50 CFR Parts 222 and 223

[Docket No.000320077-1177-02;
I.D.062501B]

Endangered and Threatened Wildlife; Sea Turtle Conservation Requirements

ACTION: Proposed rule; request for comments.

Figure 1B. Exit Hole Cover for the Standard Opening

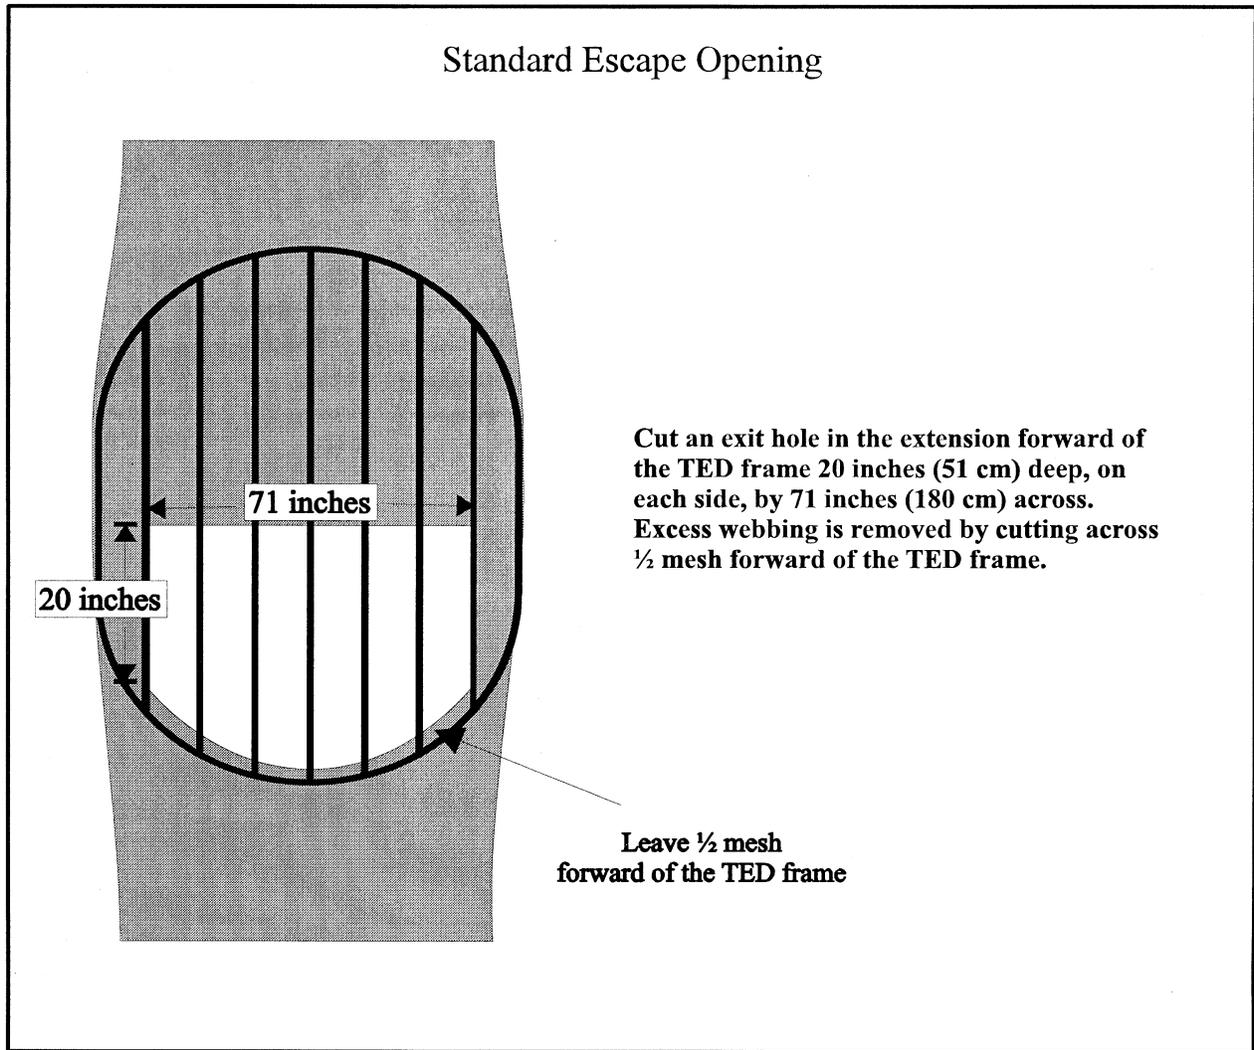
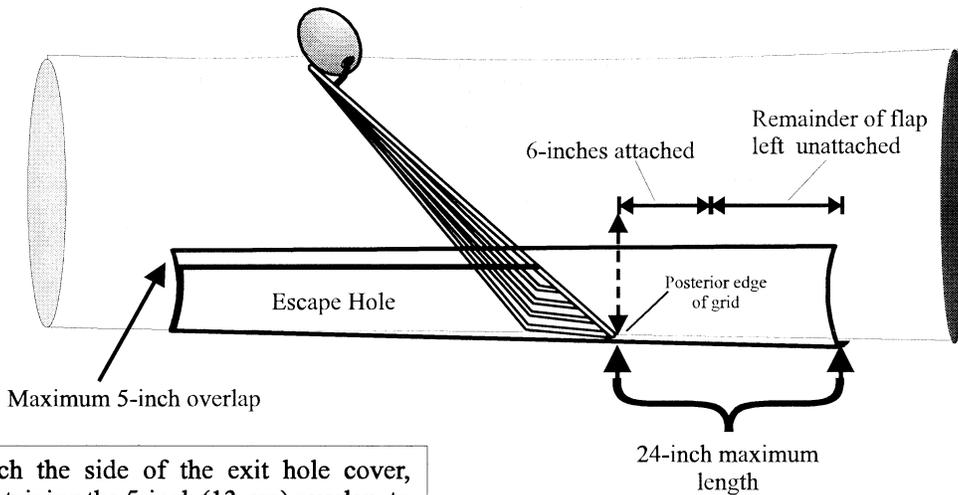
- a. Remove Figure 1, and remove and reserve Figures 2, 12A, 12B, and 15.
- b. Add Figures 1A, 1B, and 1C to part 223.
- c. Revise Figure 11 to read as follows:

(i) *Standard TED flap*. The flap must be a 133-inch (338-cm) by 58-inch (148-cm) piece of webbing. The 133-inch (338-cm) edge of the flap is attached to the forward edge of the opening (71-inch (180-cm) edge). The sides of the flap may overlap the exit hole on either side by no more than 5 inches (13 cm). The flap may extend no more than 24 inches (61 cm) behind the posterior edge of the grid (Figure 1B illustrates this flap).

The exit hole cover is made by cutting a 133-inch (338-cm) by 52-inch (132-cm) piece of webbing no smaller than 1½-inch (4-cm) stretched mesh and no larger than 1-5/8 inch (4.2-cm) stretched mesh.

The 133-inch (338-cm) edge of the cover is attached to the forward edge of the opening (71-inch (180-cm) edge). The cover should overlap the exit hole on each side by no more than 5-inches (13-cm).

Attach the side of the exit hole cover, maintaining the 5-inch (13-cm) overlap, to the side of the escape opening by sewing 22-inches (56-cm) of the cover to 20-inches (51-cm) of the opening forward of the TED frame. Behind the TED frame, sew an additional 15-inches (38-cm) of the cover to 15-inches (38-cm) of the extension.

The cover may extend no more than 24-inches (61-cm) behind the posterior edge of the TED frame.
